AIRPORT FUEL FARM DESIGN

Enel Farm Design Review

Airport Fuel Farm Plans Review

Bulk Fuel Storage and Dispensing System, Addison Airport
The “Bad Boy” list as of 7-26-04:

CONCEPT SITE PLAN
BULK FUEL STORAGE AND DISPOSING SYSTEM

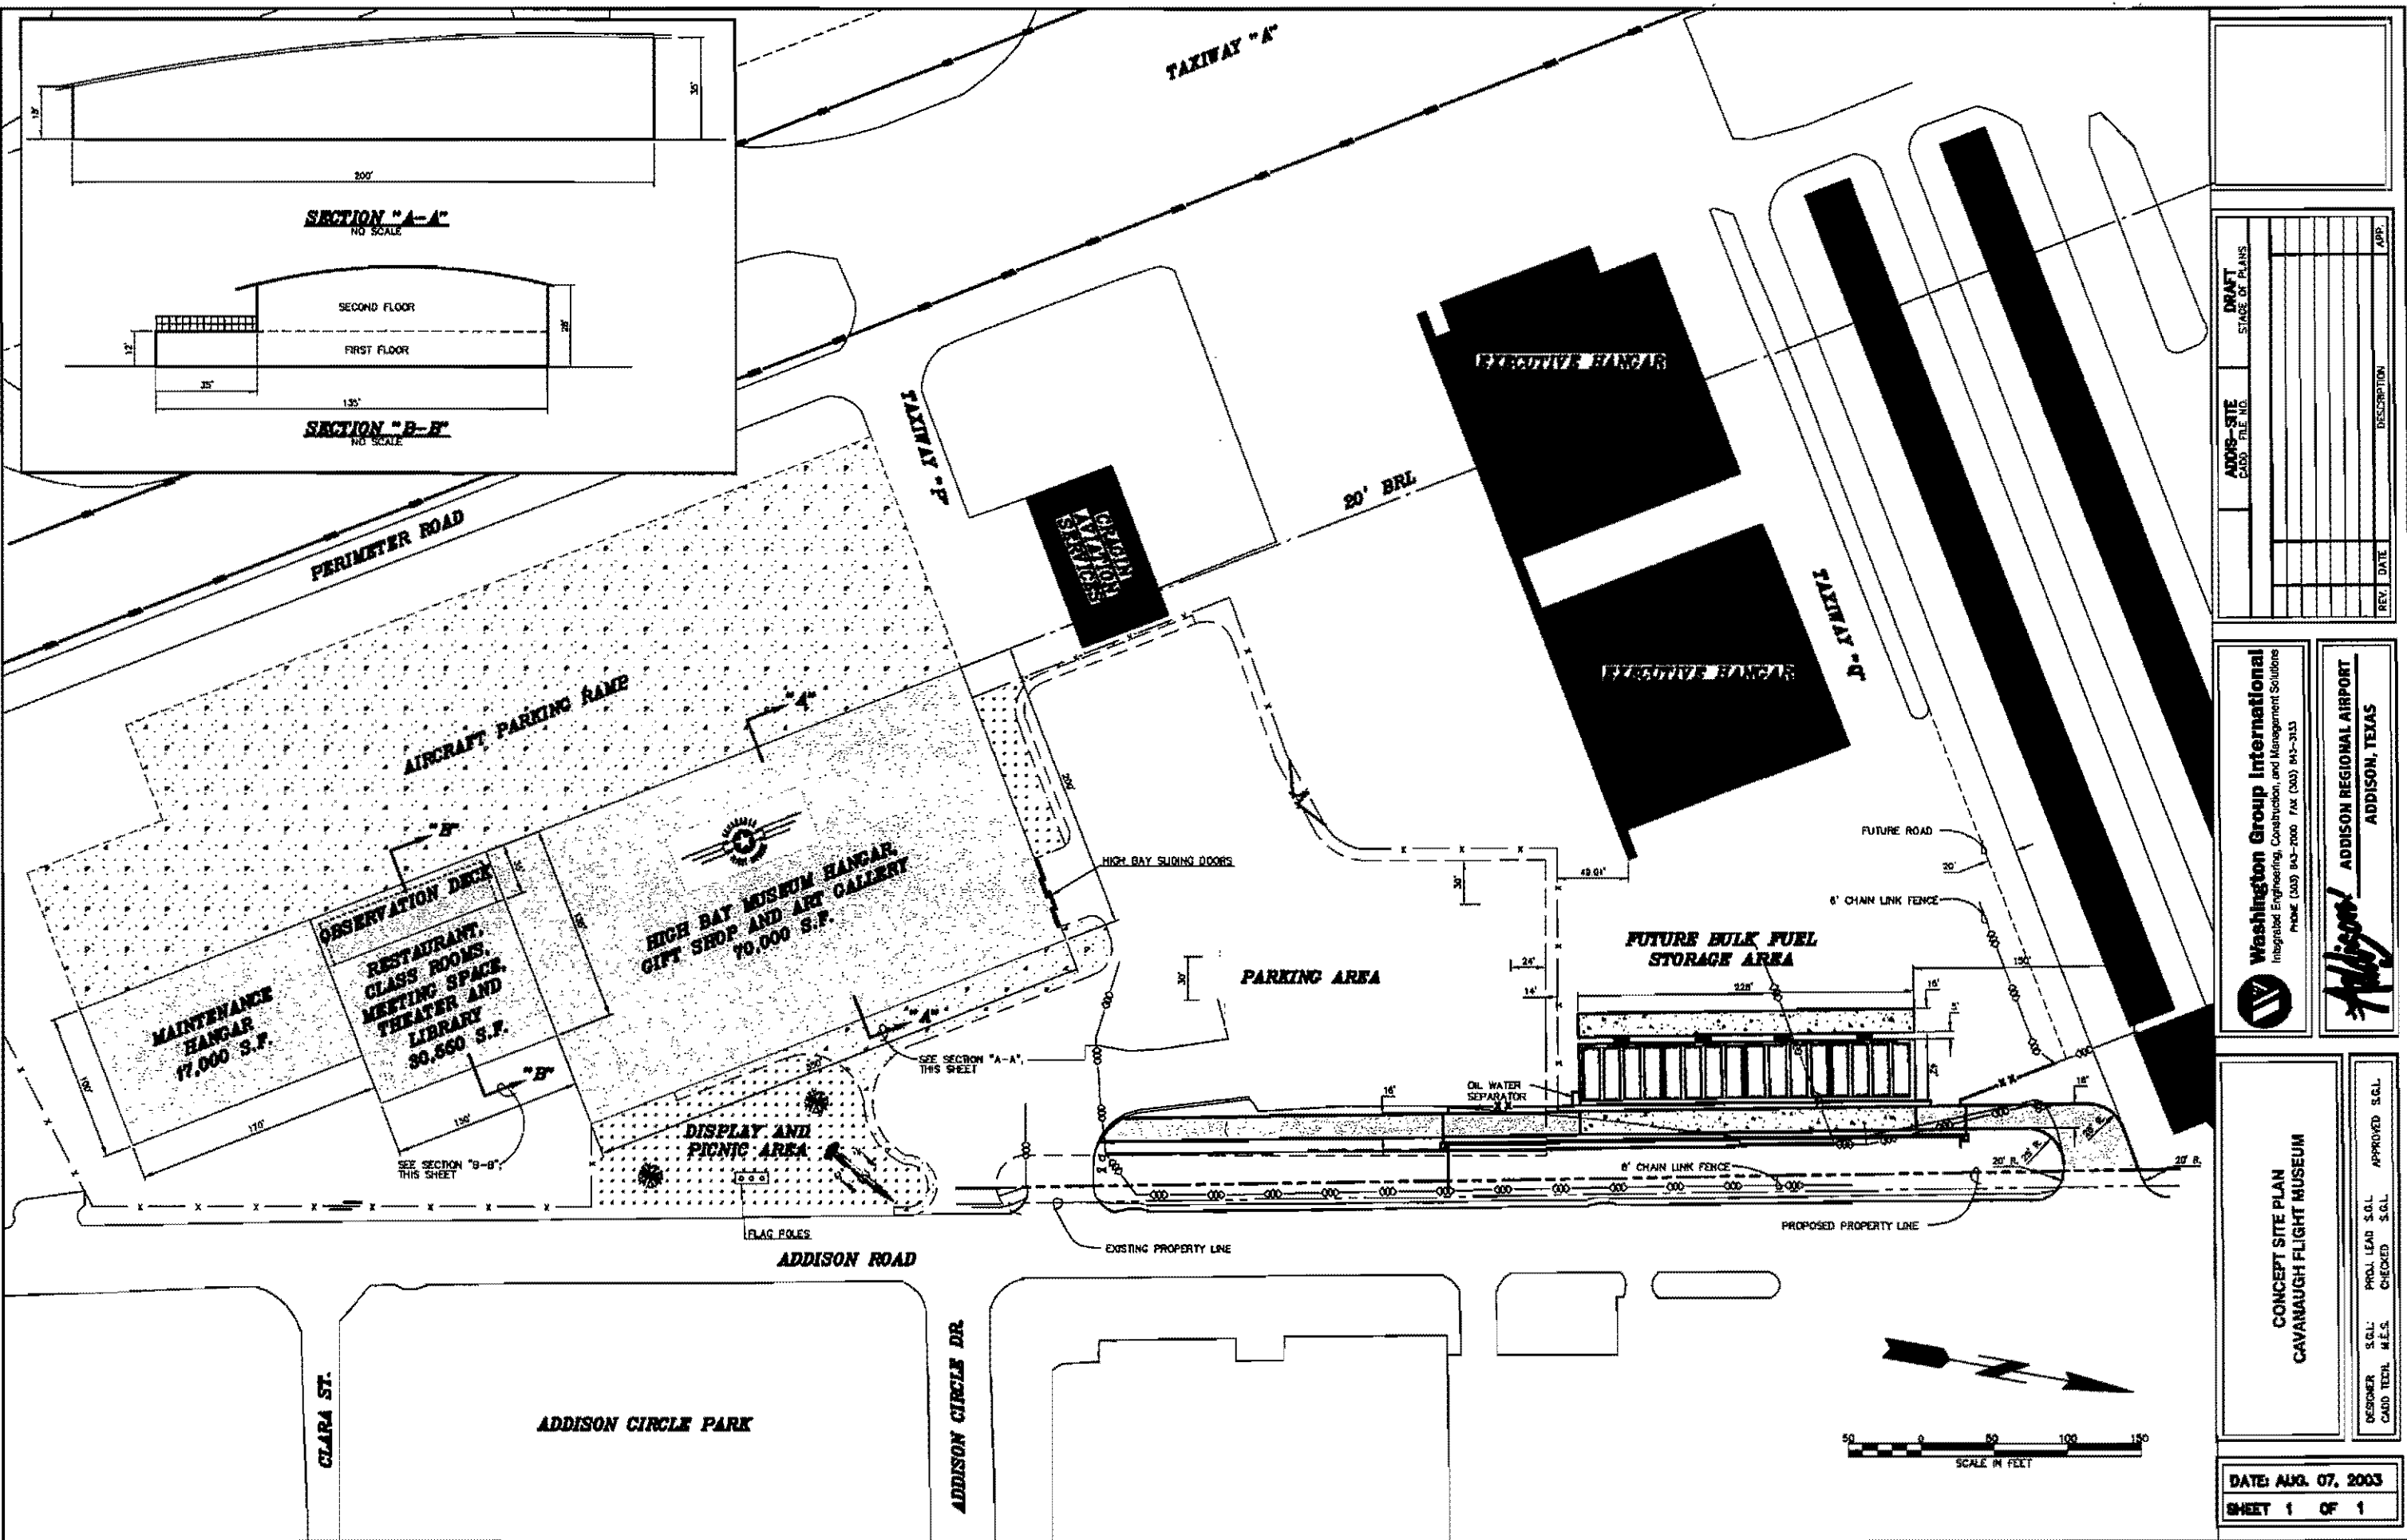
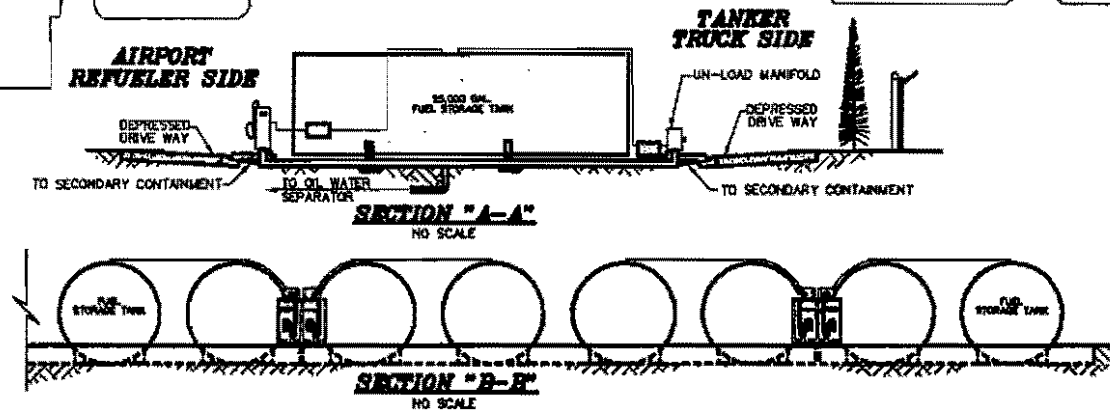
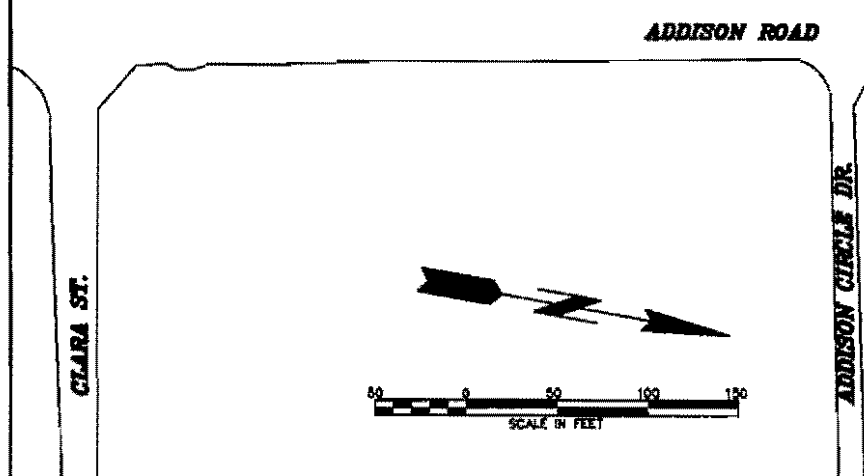
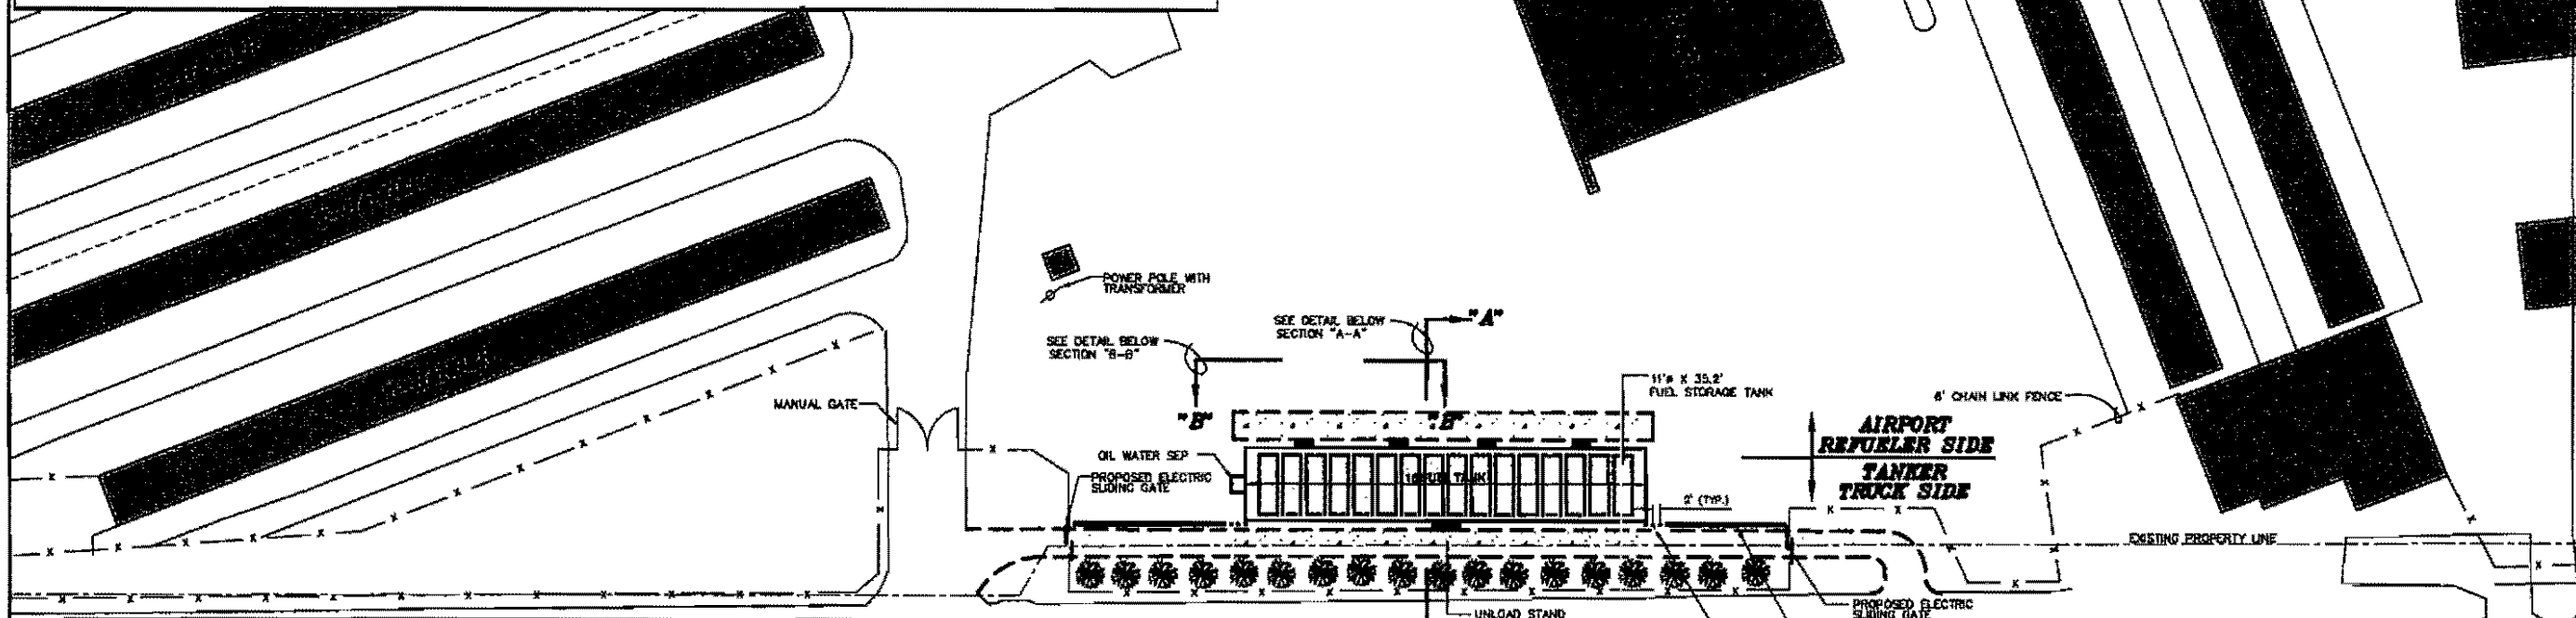
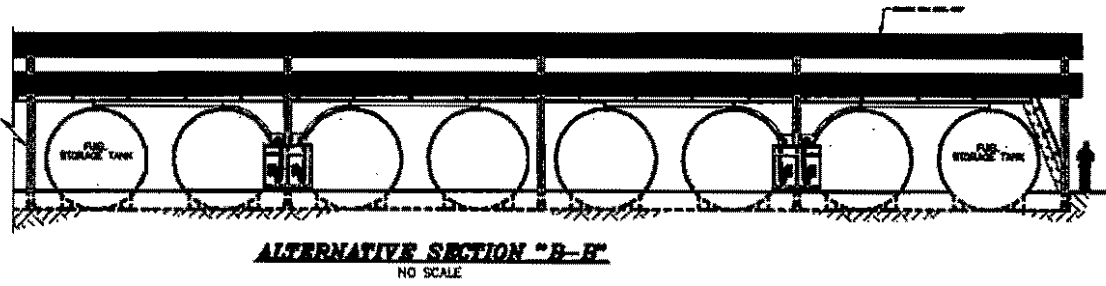
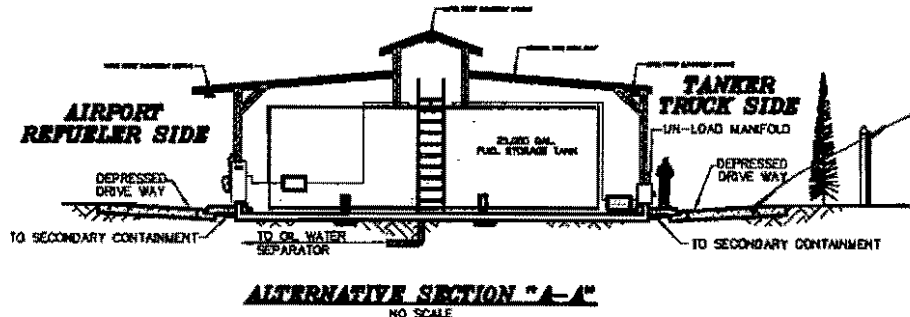
Doesn't roadway need to be higher than containment wall for post leakage into containment?
